BURNETT RIVER FLOODPLAIN ACTION PLAN

COMMUNITY REFERENCE GROUP MEETING

MINUTES

**Preliminary Mitigation Options for MCA
 Rubyanna Bypass Channel**

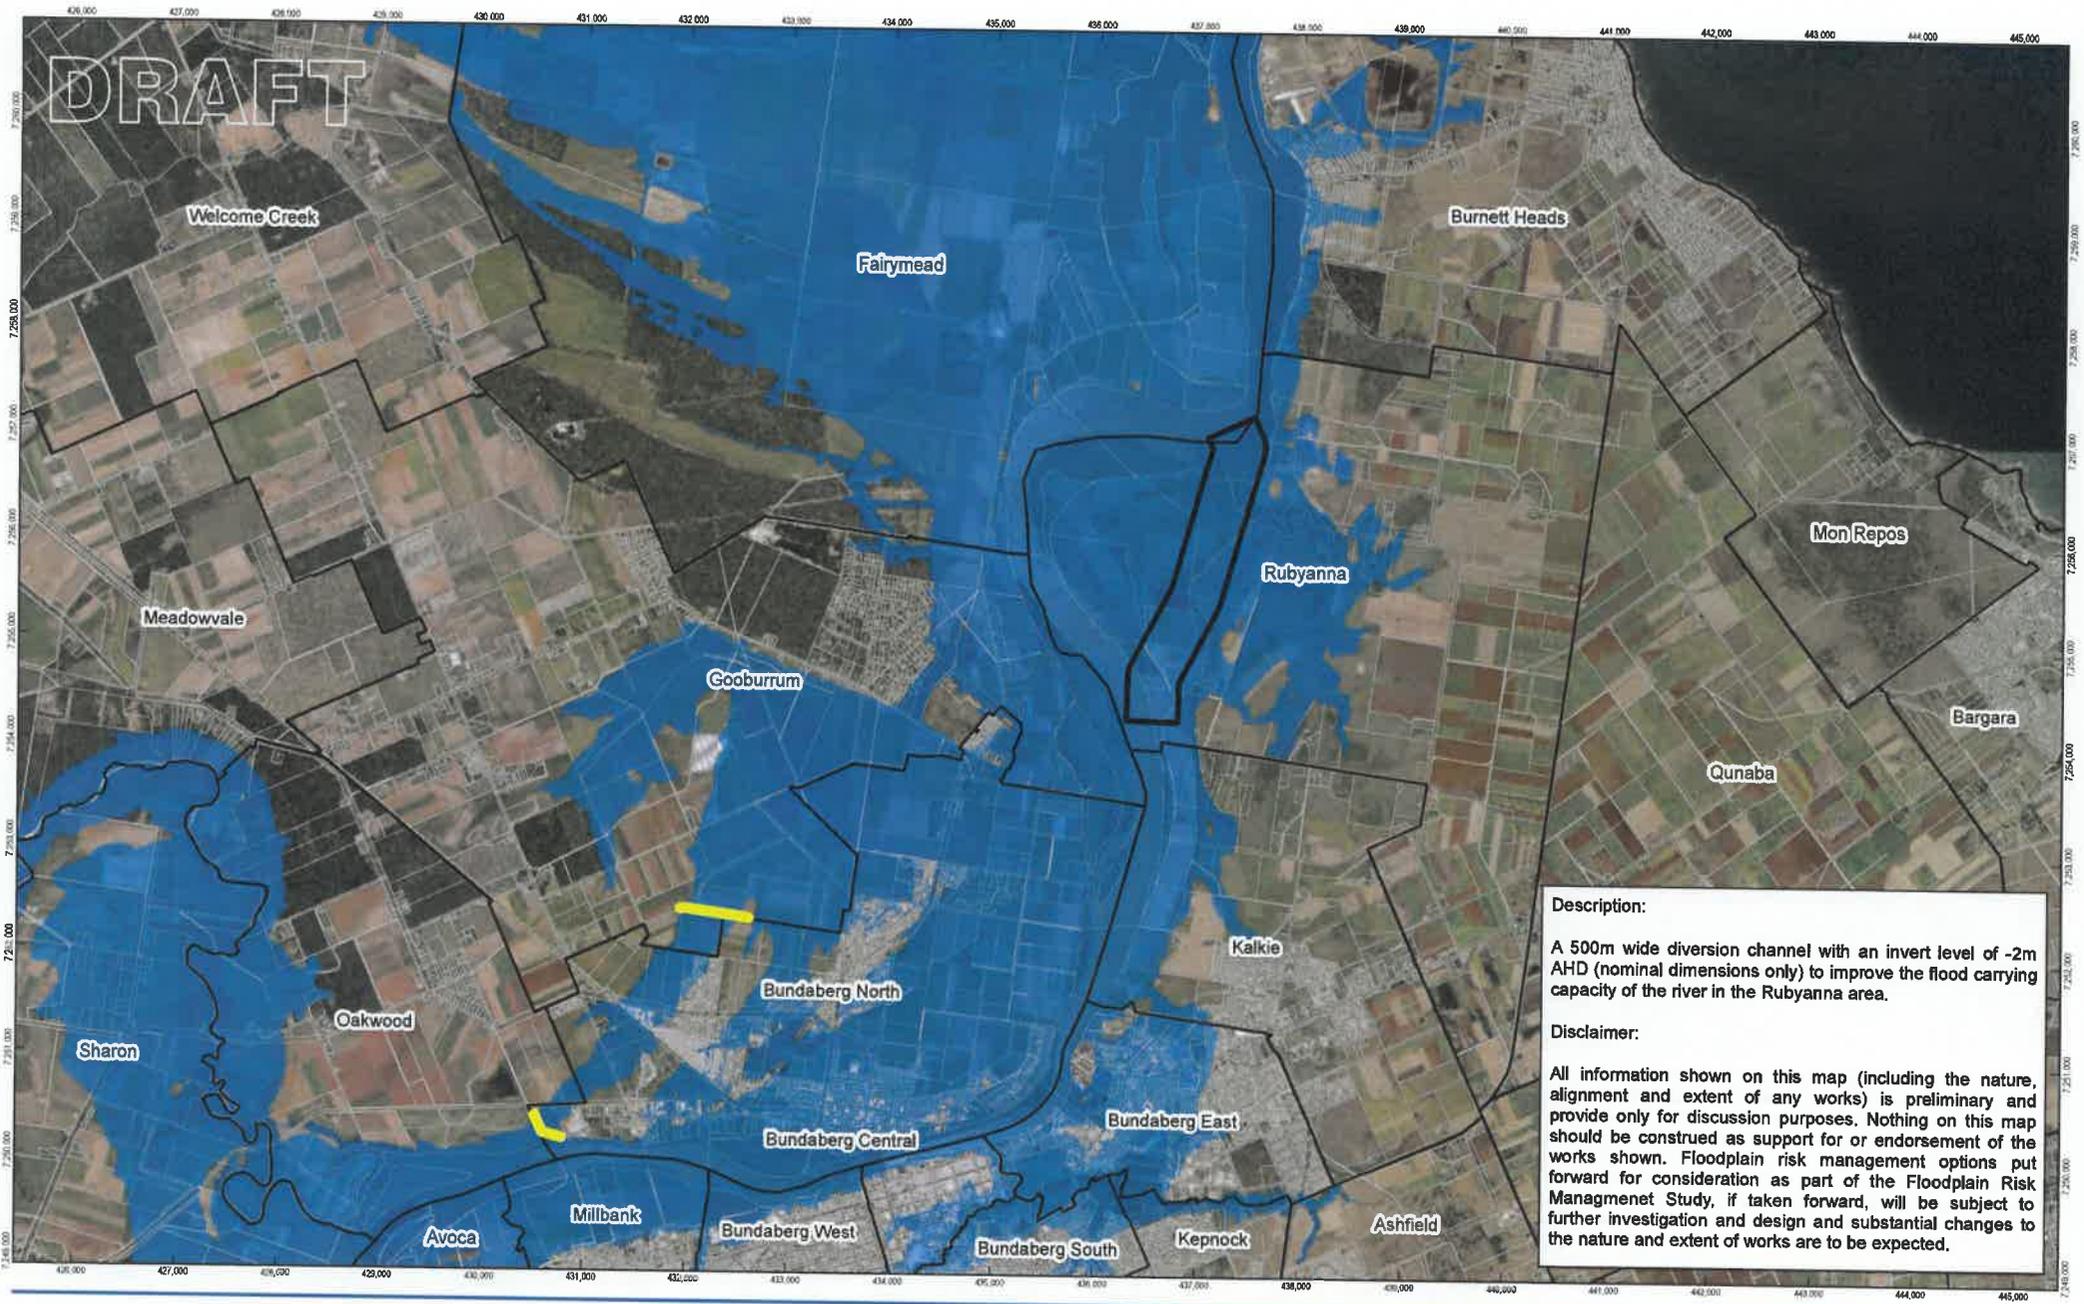
CRG Member, Jon Carman enquired about the extent of benefits to be received from the proposed Rubyanna diversion channel (Option 20) and Dan Copelin advised that early preliminary testing had shown that the benefits depleted upstream of Paddy's Island.

**Preliminary Mitigation Options for MCA
 Removal of Ben Anderson Barrage**

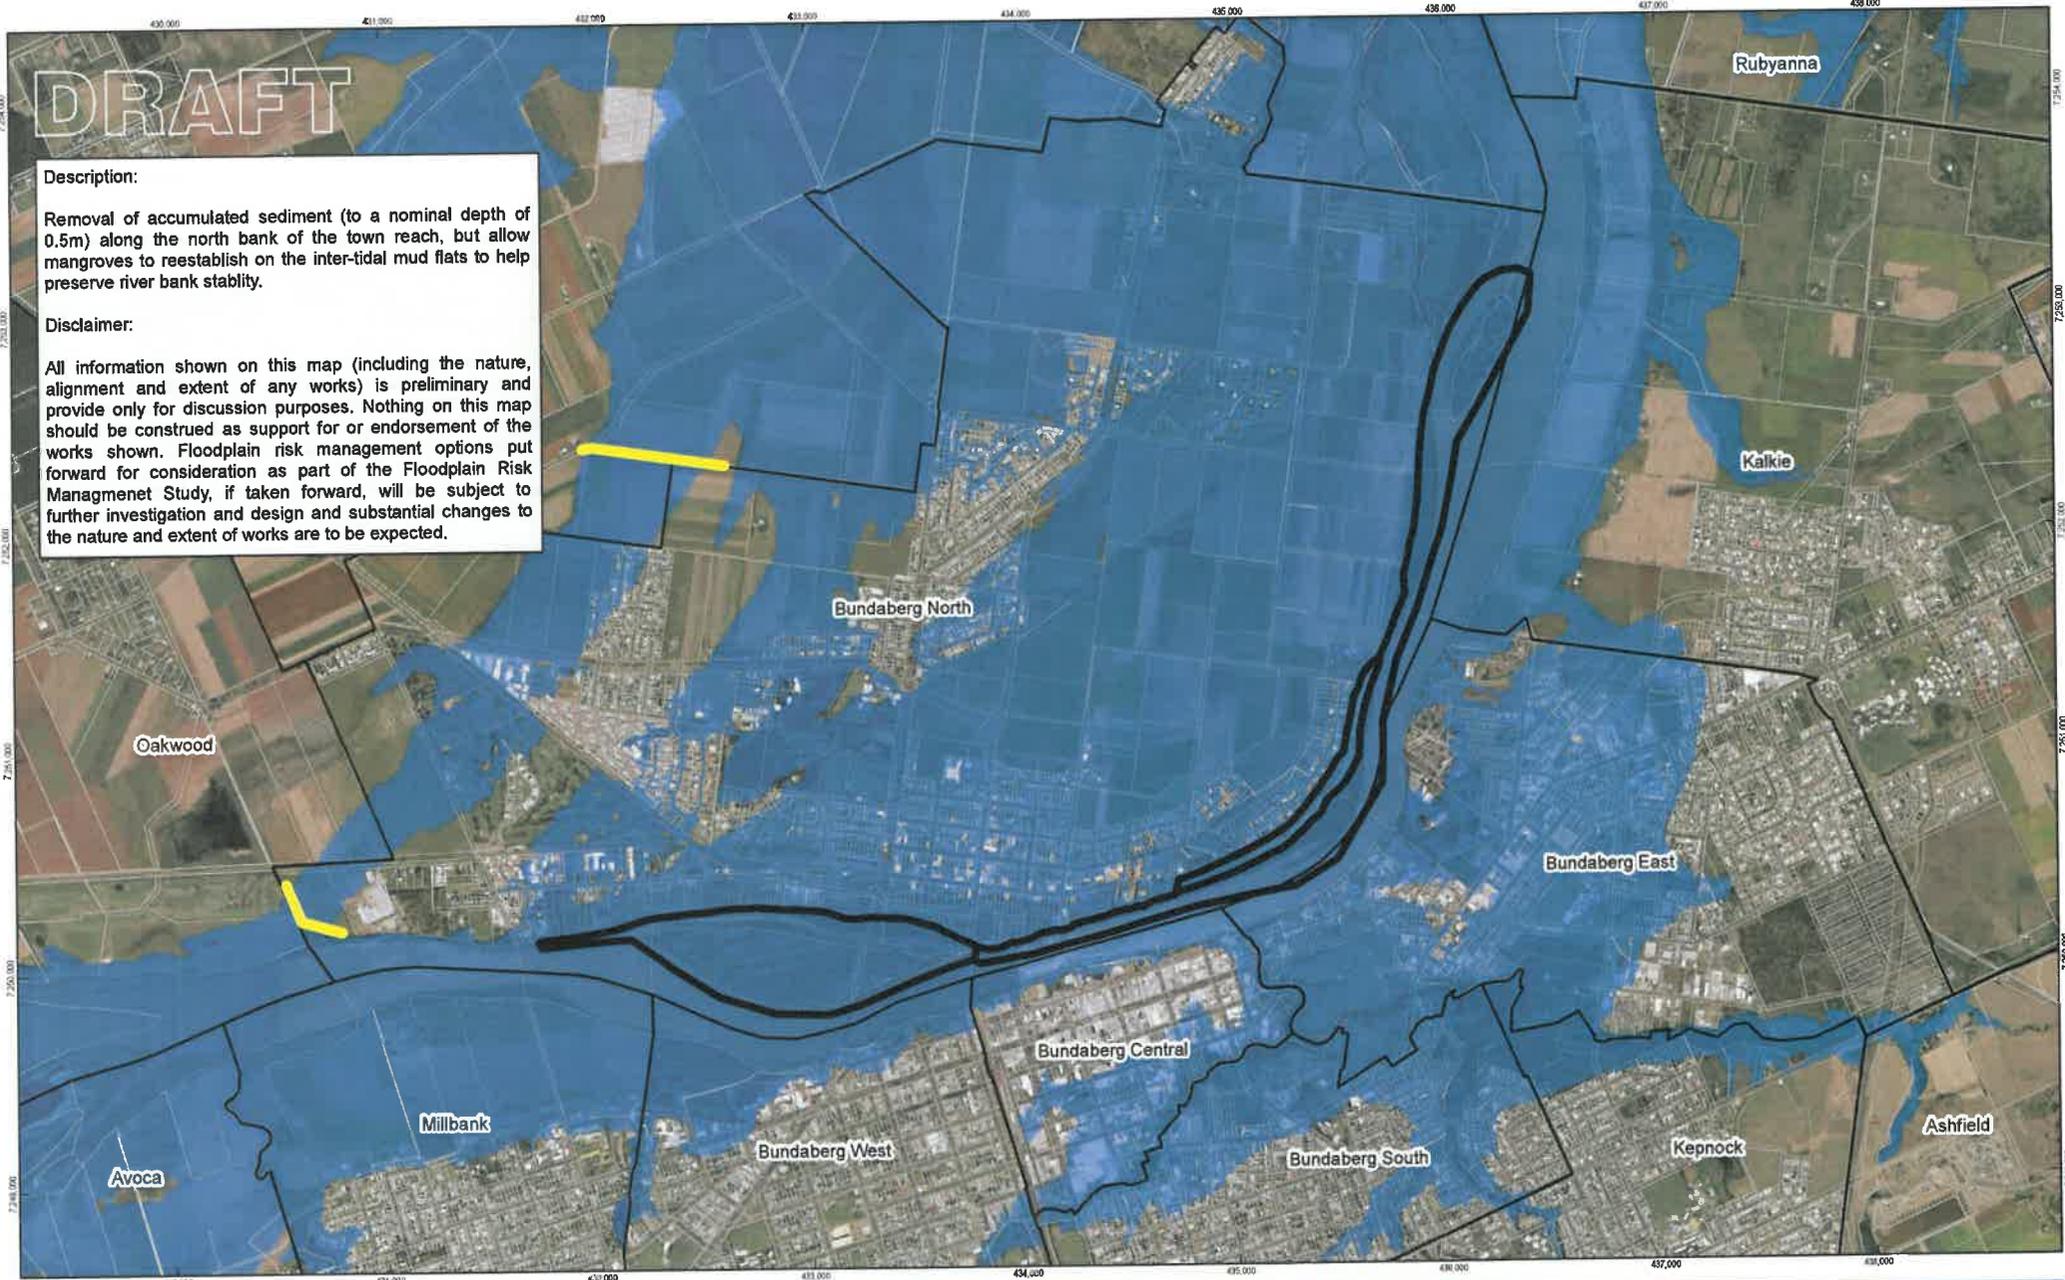
John Olsen spoke regarding this proposal to remove Ben Anderson Barrage (Option 28) and tabled additional information (attached to these Minutes). In reply to John Olsen's comments, Dan Copelin clarified his comments of 'major implications for water supply' by stating that he did not mean it was impossible but would incur high costs to secure and deliver an alternative water supply. Dan Copelin also pointed out that securing a supply of water in drought years would need to be considered. John Olsen reiterated previous comments that modelling should be undertaken from a pristine state of the river to fully understand the elevated state of the river since construction of Ben Anderson Barrage. At this stage, Dan Copelin referred the Meeting to his email circulated prior to this Meeting, answering the concerns raised by John Olsen (copy attached). To address the first issue, he stated that preliminary modelling showed the removal of Ben Anderson Barrage to offer a reduction of 1 – 2 cm in flood height during a 2013 flood event. Whilst it looks like a large imposing structure, the barrage has a crest level of about 2m and the flood level in 2013 was approximately 14 metres. The structure is low compared to 2013 flood levels so it is not exerting an impact on peak flood levels upstream or downstream of the barrage. He further stated that this does not mean that the barrage would not have an affect in smaller flooding. He reiterated previous comments by stating that restrictions other than the barrage (such as Millaquin bend) were driving the high flood levels rather than other structures built in the river. The second issue raised by John Olsen was the affect on flood levels caused by increased rate of sedimentation upstream of the structure. Dan Copelin agreed that it was probably true that the barrage had caused sedimentation upstream of the structure and referred to previous studies undertaken after the barrage was built. These sediment transport studies found that the barrage did not substantially contribute to reduction in river depth. It was noted that sedimentation occurs naturally and that sedimentation may have built up even if the barrage had not been constructed. Currently, the barrage is likely holding back sedimentation upstream of the structure and it can only be concluded from our limited knowledge that the barrage is not contributing to sedimentation downstream. The hydraulic studies undertaken in the 1980s and 1990s are not clear about a moderately silted up river

flooding to higher depths given that flooding scours sediment anyway. Dan Copelin stated that the removal of Ben Anderson Barrage was omitted from the list of proposed flood resilience projects in view of the preliminary modelling results, the findings in the 1980s and 1990s hydraulic studies and major implications for water delivery and security of supply in drought conditions.

John Lee asked Dan Copelin if the barrage had any impact on the flow of the river in the 2013 event and Dan Copelin replied stating that the barrage is located on a straight reach of the river and had no affect on direction of flood waters. Whilst there is evidence of the river meandering in the lower reaches throughout time, there is no evidence of this happening in the stretch of river where the barrage is located.

the GHD response to this subject matter, "The removal of Ben Anderson Barrage", does not really address the area of my concerns, which is elevated river heights during times of flooding.

I wish to provide the following information to contribute to the discussion on the Ben Anderson barrage. You will note in my memo outlining the list of options for the MCA that the barrage removal option will not be taken forward as part of GHD's MCA. We made this decision primarily based on hydraulic modelling of the impact of the barrage. We will have the opportunity to discuss this information further during today's meeting. This information is provided for discussion purposes only and further detail and explanation will be provided in the final Floodplain Risk Management Study Report.

As part of the Burnett River Flood Study (refer to Section 11 once the report is available), GHD conducted a sensitivity test on the hydraulic model whereby the Ben Anderson barrage (as well as the bridges in the town reach) were removed from the model. The change in flood level for the 2013 event was calculated. The below is a screenshot of these results, where the points are labelled with the change in flood level in metres:

As seen, the removal of the barrage (and bridges) only reduces flood levels by 1 or 2 cm. This is not a significant effect, and is not an effective method for mitigating flooding. The primary reason for this very small effect is that the barrage is a relatively low structure (crest level 2.1m AHD) and the 2013 flood level at the barrage was about 12m higher than the top of the structure (flood level ~14m AHD at that location). The barrage was therefore completely drowned and exerted no significant impact on peak flood levels. This is true for all significant floods. The barrage would have a more pronounced impacted during minor river flows (where the water level downstream of the barrage is not much higher than the crest), however these flows are generally below the threshold of damaging floods and reducing water levels in these situations will not deliver benefit to the community. The below figure from the flood study shows this effect, where only a minor perturbation in the water surface is evident at the barrage. Far more significant are the locations circled in red, where constrictions in the river cause a significant increase in flood levels upstream.

Preliminary Mitigation Options for MCA Reopening of Skyringville Passage

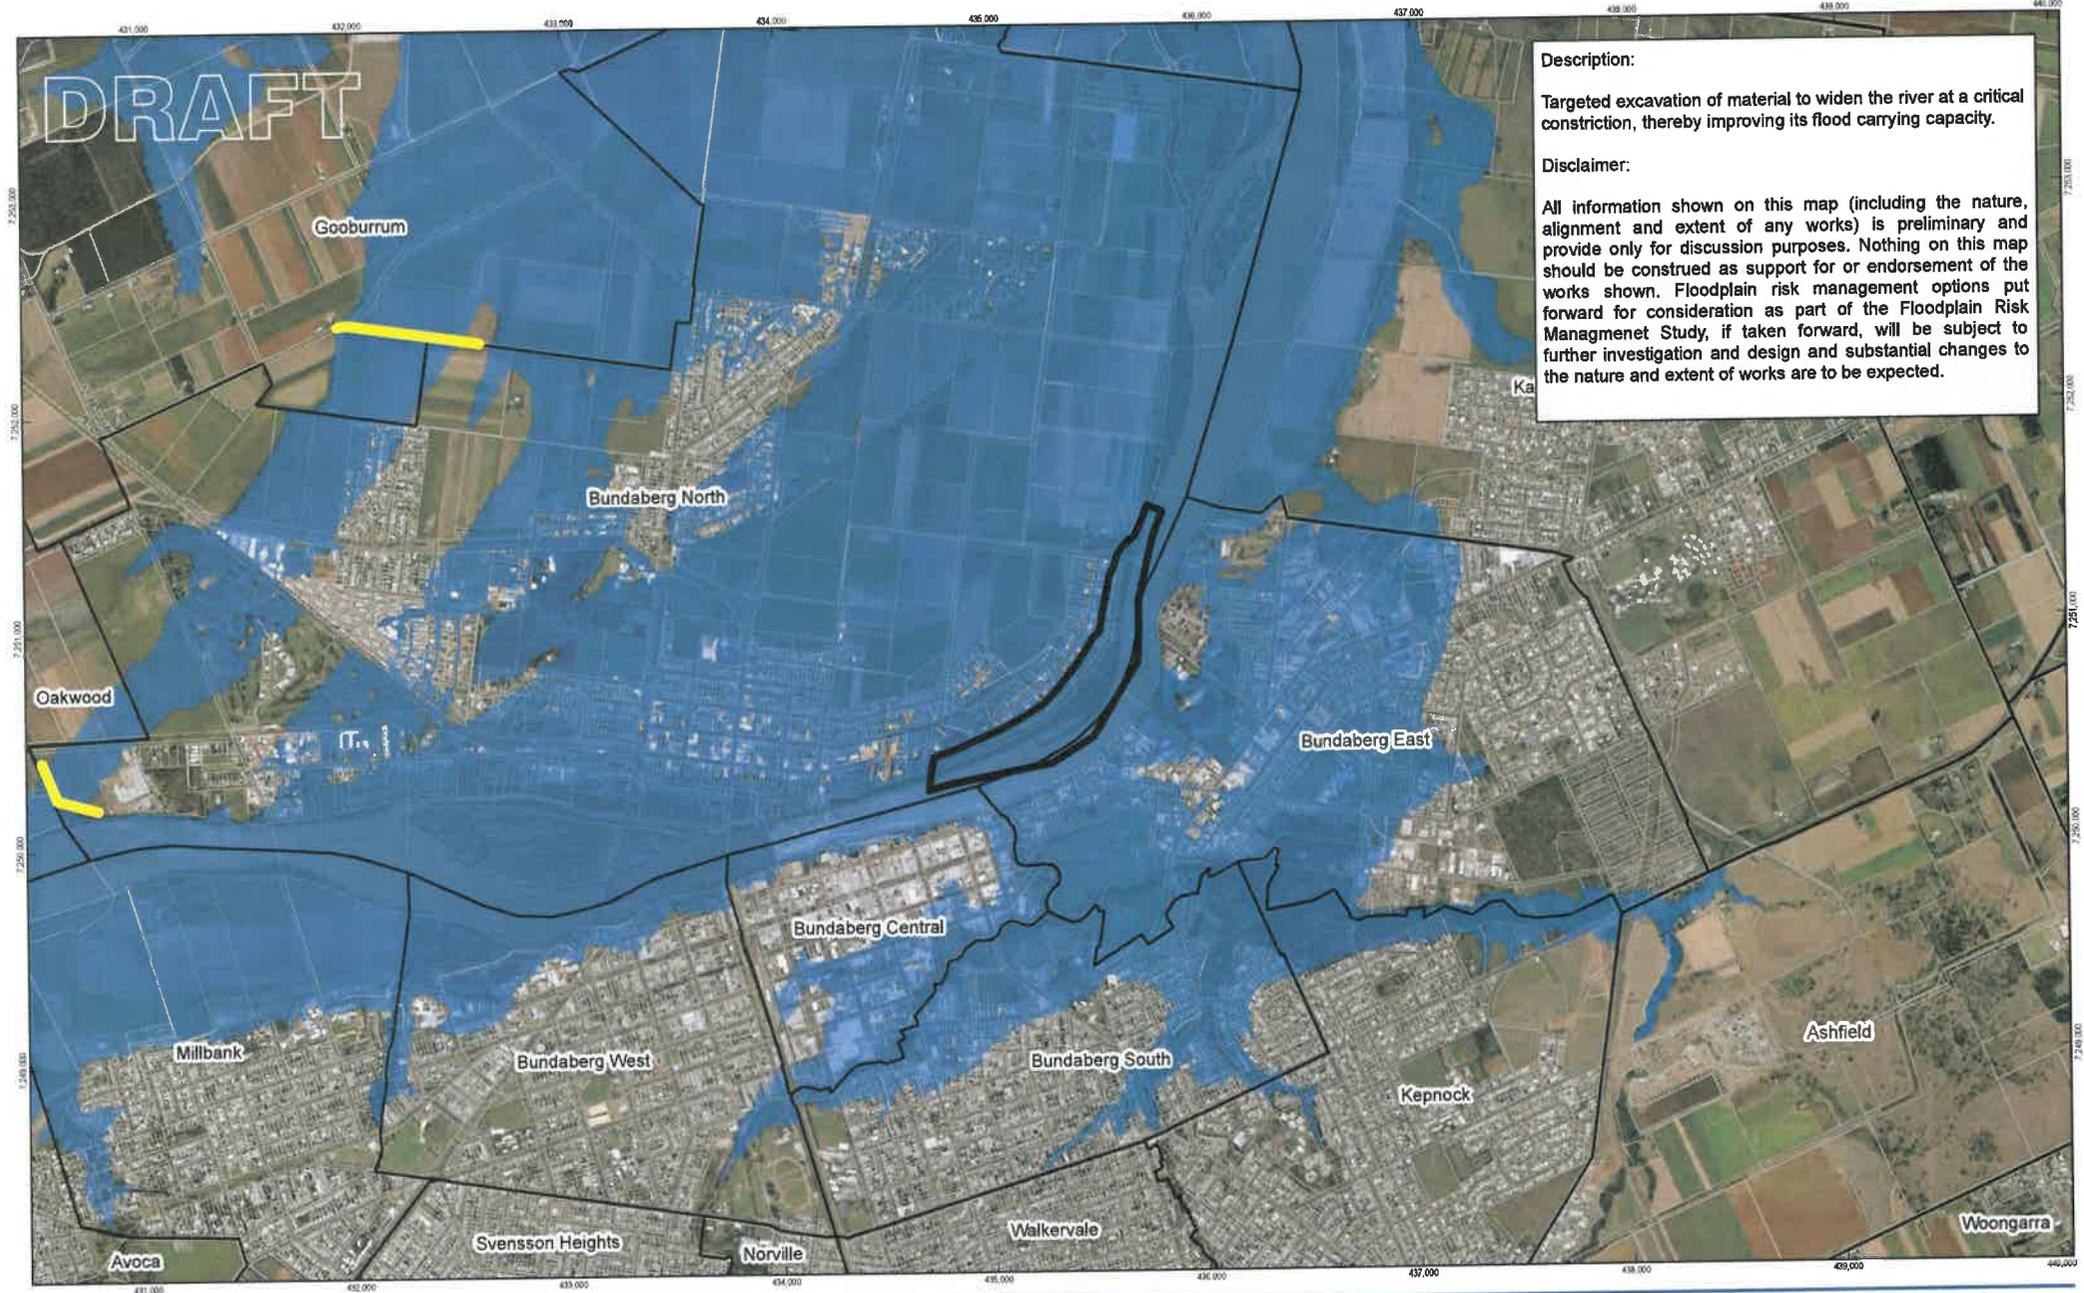
CRG Member, Barry Ehrke outlined the reasons for his proposal to open up Skyringville (Option 30) and stated that from his experience, you always start at the mouth and open it up first. In reply, Dan Copelin advised that preliminary modelling had shown that removal of certain restrictions in the river had a greater effect than opening up the mouth. The recent dredging undertaken at Port Bundaberg had been included in the model. Preliminary testing (for a 2013 flood event) of diversion channels and re-opening the Skyringville passage (as described in options 30 and 21) only provided a benefit to the area around the Port of Bundaberg and offered no benefit to the populated areas further upstream. He further stated that widening the river at Millaquin Bend (Option 31) offered a substantial benefit to the city area. Whilst the river mouth is a constraint, there are so many places for the flood waters to release, that widening the mouth does not provide much relief to the flooded areas of the city.
